TECHNICAL BULLETIN TR-20

CHASSIS MODEL: UD1200/UD1400/UD1800CS

AISIN ATM SPEEDOMETER DRIVEN GEAR CHANGE

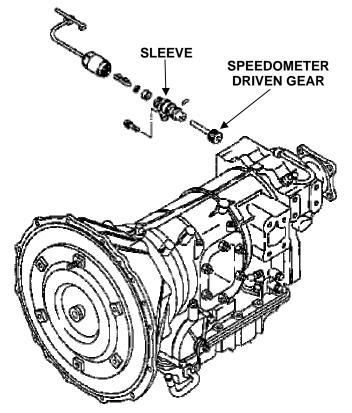
To advise UD Truck Dealers that the speedometer driven gear for the Aisin ATM has been changed to a steel gear.

2004 Model Year vehicles built after August 1, 2003 with an Aisin ATM have the steel driven gear.

All remanufactured Aisin ATMs will have the steel speedometer driven gear installed starting May 18, 2004 with serial number 04EM1270R.

Remanufactured units equipped with the speedometer steel driven gear can be identified by the presence of the speedometer driven gear and sleeve, as shown in the illustration above, that has been installed by the remanufacturer.

DO NOT REMOVE THE STEEL SPEEDOMETER DRIVEN GEAR.
